DATE: 05.23.2018
TO: ProTrak
FROM: Mitesh Baxi
Traffic Engineering

■ **CALIBRATION STATION OFFICES [TRC Plan Review]**

↻ Initial Review Note ↻

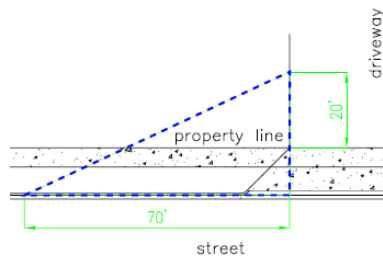
- The site is within 250' of a street intersections. Revise all sheets to accurately illustrate the existing conditions on and surrounding this parcel. Show all adjacent traffic signs, lane configurations, traffic control devices and pavement markings for the intersections of Burnett Blv, Virginia Ave, Southern Blv and Harrison St on the site inventory plan. Please refer to the Technical Standards and Specifications Manual (link is below) Ch. VII C.1.a.2. for specific information and distance requirements. Contact Traffic Engineering at 341-7888 if you need assistance locating these elements.
